ALERT SERVICE BULLETIN

UH-1H-11-07

**MODEL AFFECTED:** UH-1H

**SUBJECT:** MAIN ROTOR HUB INBOARD STRAP FITTING 204-012-102-005/-009, ONE TIME MAGNETIC PARTICLE INSPECTION OF.

**FIGURE 1**

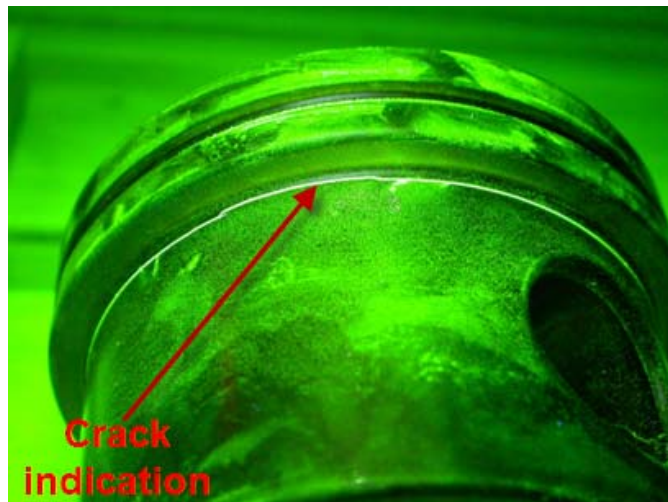
Bell Helicopter has determined that main rotor hub inboard strap fittings may fracture as a result of a non-conformance. The possibility exists that cracks occurred during the quenching operation which were not detected during manufacturing inspections. Additionally, some 204-012-102-005 fittings were shot-peened and the resultant material rollover at the edges of the parts may not have been properly removed during manufacture. This raised material may lead to the formation of fatigue cracks.

4. Perform magnetic particle inspection on 204-012-102-005 and -009 inboard strap fittings IAW applicable maintenance manual. Refer to figure 1 for typical quench crack and location found during magnetic particle inspection. Additionally, carefully inspect all edges of the 204-012-102-005 fittings for cracks:

- a. If cracks are found on either the -005 or -009 fittings, the fitting is unserviceable and must be replaced, proceed to step 7.
  - b. If no cracks are found on the -005 fitting, proceed to step 5 for an additional inspection. If no cracks are found on the -009 fitting, proceed to step 6.

5. If no cracks are found on the 204-012-102-005 fittings:
  - a. Visually inspect all edges for raised material (shot peen rollover). If raised material is found, remove by hand using an India stone. Maximum material removal is 0.010 inch x 40 to 50 degrees. If raised material cannot be removed within specified limits, fitting is unserviceable and must be replaced, go to step 7. Otherwise proceed to 5.b.
